Sedan Range

08.2-01

TECHNICAL BULLETIN

Transmission MIL Illumination – Revised EPROM – Replacement Procedure

ILLUSTRATION 3

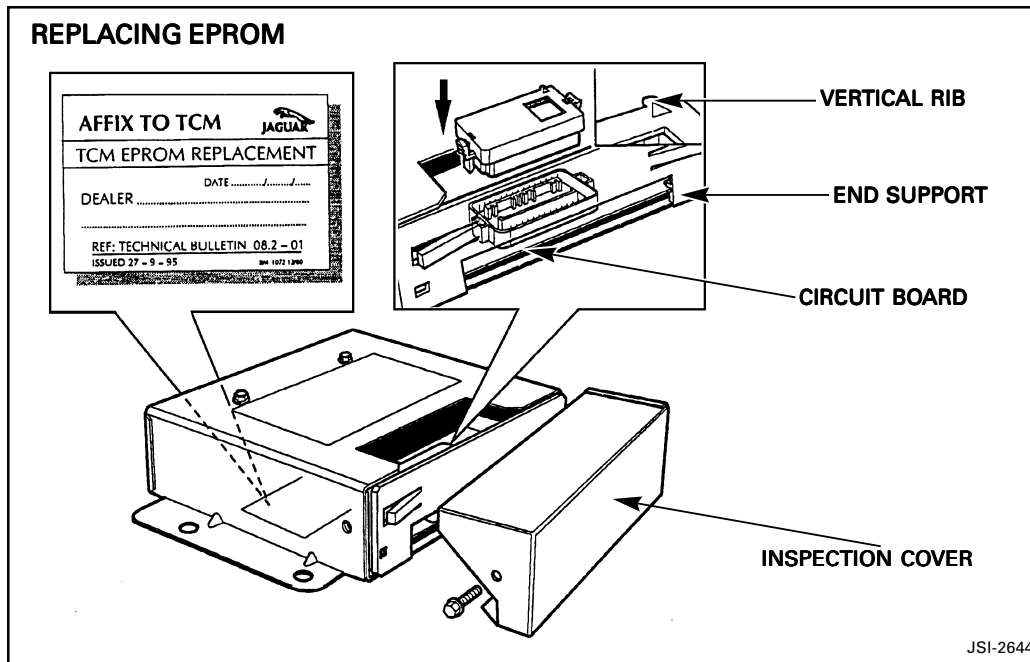
5. Place the TCM on a clean bench area and remove the TCM inspection cover (Illustration 3).

CAUTION! The end support (Illustration 3) is free to move when the inspection cover is removed and must be held in place. Support the circuit board through the opening in the end support to prevent the board from bending and possibly cracking while removing and installing the EPROM.

6. The EPROM has a retaining latch at each end. These latches must be pressed in while removing the EPROM from the socket. Press the latches inward and ease each latch free of the socket. Then, carefully remove the EPROM module from the circuit board.
7. Align the vertical rib (Illustration 3), indicated by an arrow, on the replacement EPROM with the rib on the socket to ensure correct alignment.

Install the replacement EPROM module in the board socket while holding the board through the opening in the end support. Press the EPROM down into the socket until the latches engage.
